Date of Issue: June 3, 2016

Japan Civil Aviation Bureau
 TAIKUSEI-KAIZEN-TSUHO
Airworthiness Directive

1. Applies to: Kawasaki BK117 series helicopters equipped with a Goodrich rescue hoist assembly having a Part Number (P/N) as listed in Table 2.1 of this AD.

Figure 1

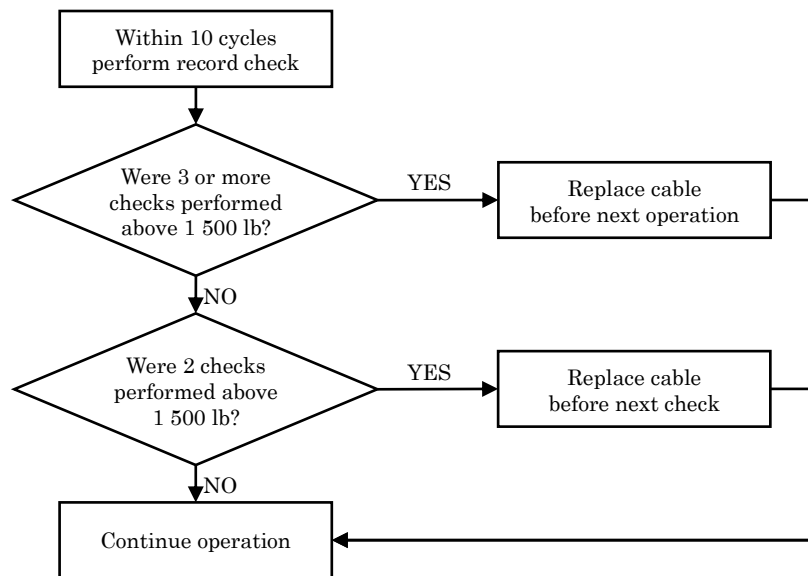
2.1 Within 10 hoist operating cycles after the effective date of this AD, accomplish a records check to determine whether, during any previous hoist load check/test, a cable was load-tested (average of 5 pulls) at 1 500 lb [680 kg] or more. If any cable is identified to have exceeded this limit during two or more hoist load checks/tests, replace the affected cable with a serviceable cable within the time interval shown in paragraph 2.1.1 or 2.1.2 of this AD. For replacement of a cable, see figure 1 of this AD.

2.1.1 If any cable is identified to have exceeded this limit during three or more hoist load checks/tests, before next hoist operation, replace the affected cable with a serviceable cable.

2.1.2 If any cable is identified to have exceeded this limit during two hoist load checks/tests, before the next hoist load check/test, replace the affected cable with a serviceable cable.
